**Applicant's Supplemental Response #2 to CEC Staff
Data Request Set 1A
(Nos. 5, 8, 15, 16, 22, 43, 55, and 57)
for the APPLICATION FOR CERTIFICATION
for the Rio Mesa Solar Electric Generating Facility
(Rio Mesa SEGF)
(11-AFC-04)**

Subject: Supplemental Response #2 to CEC Staff Data Request Set 1A (#s 5, 8, 15, 16, 22, 43, 55, and 57) Rio Mesa Solar Electric Generating Facility (11-AFC-04)

ELEVATION VIEW LOOKING EAST

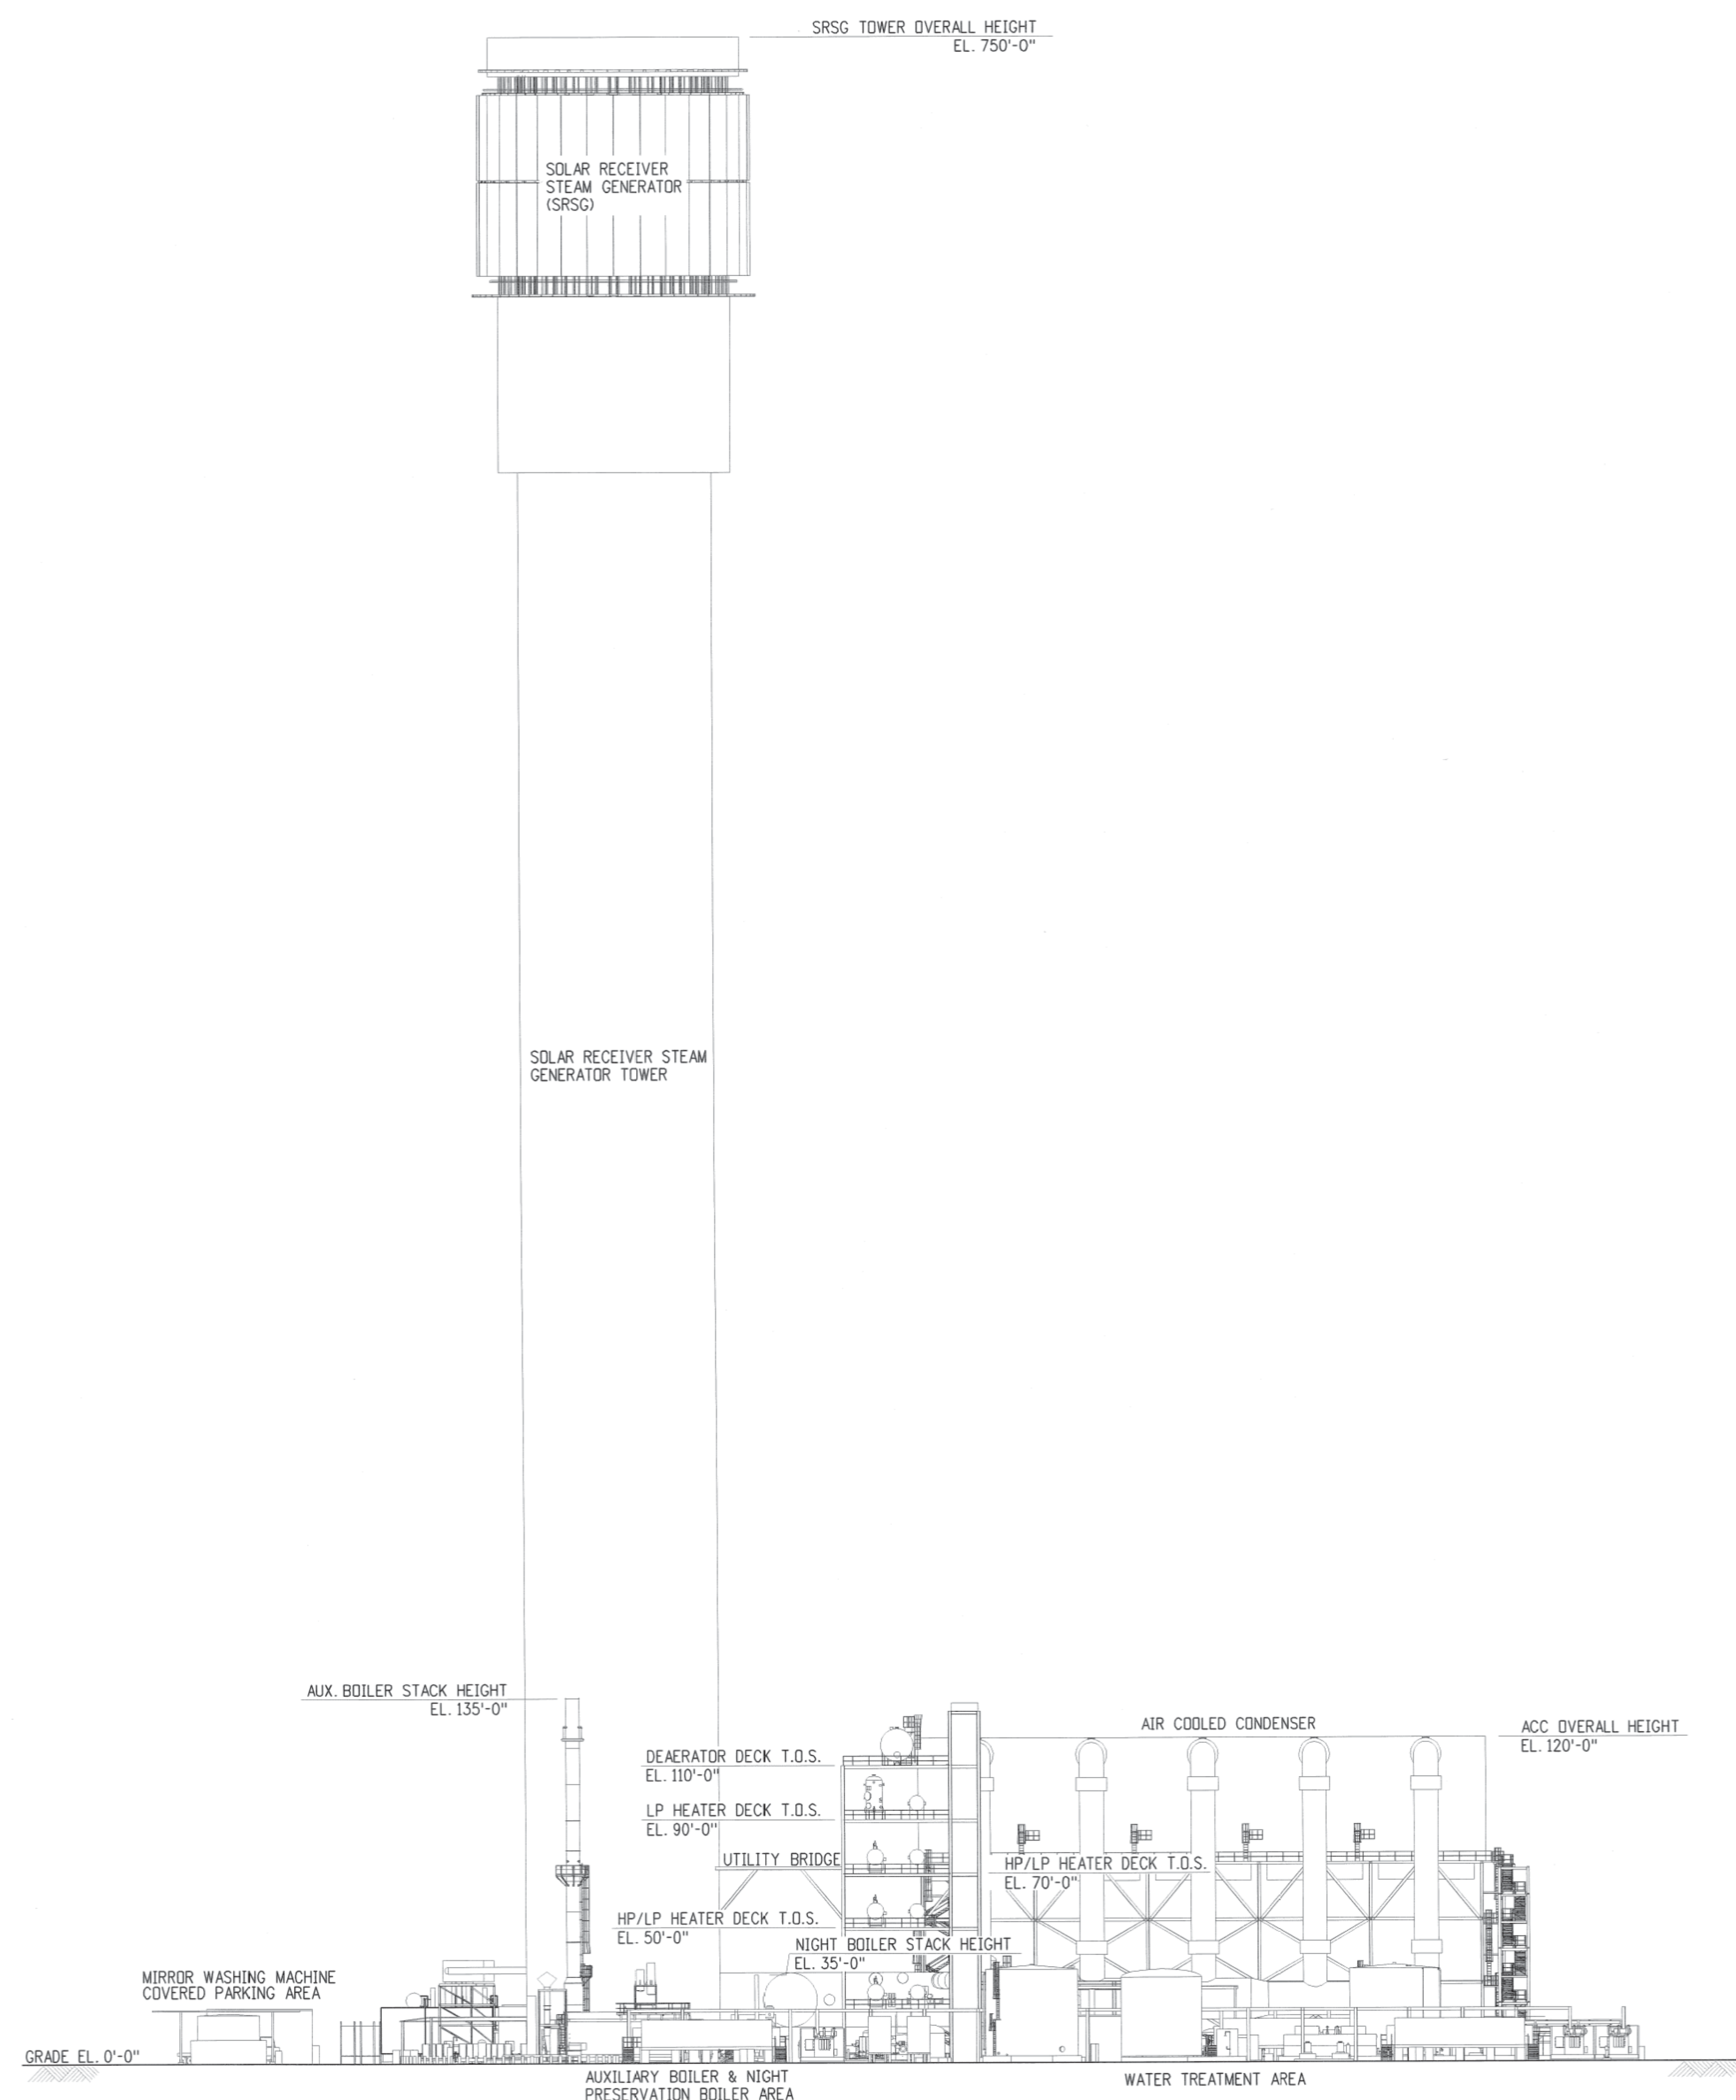
The Boiler Optimization reduces the number of boilers at each power block from five to two. The three, large auxiliary boilers will be eliminated, while the medium-sized and smallest boilers will remain. The operation of the remaining boilers will be modified to support the operation of the solar receiver steam generating system (SRSG) in a more efficient and effective manner.

of the power block has been revised. Figures 2-3-R1, 2-5-R1, and 2-8-R1 show the updated plot plan. In addition, Figures 2-9 a through d provide Boiler Optimization elevation drawings.

Figure 1. 3-D flux map model on cylindrical sections above the solar field at maximum load (maximum flux requirement); only flux density $>10\text{kW/m}^2$ is shown.

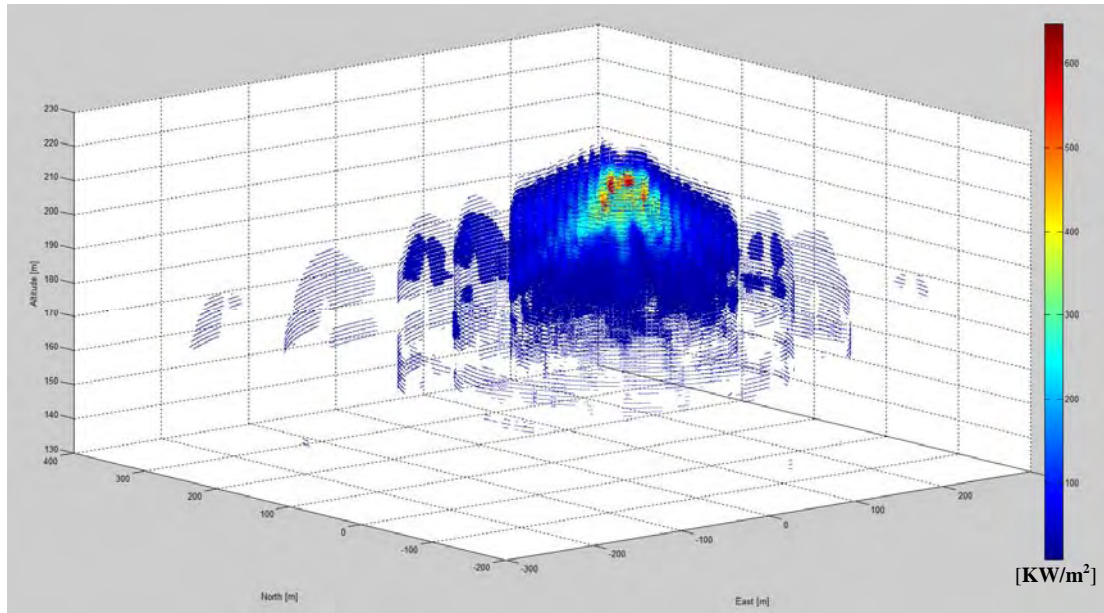
55. *Please provide data (developed using Pro E, Solid Works or other equivalent 3D modeling package) showing expected energy flux emitted from each tower over a 24-hour period under several different weather (e.g., wind speed) scenarios. Translate this energy flux into expected increases in ambient temperature applied to a body located between the receiver, standby points/ring, and heliostats as well as changes in light and humidity between these locations. Based on 1-hour intervals, state the temperature applied to a body, humidity, and light at the top of the tower, and extending outward at reasonable, regularly occurring heights and distances. Please provide staff both a model and to-scale renderings shown in top down and side view.*

Figure 1 provides a 3-D view of the model output.
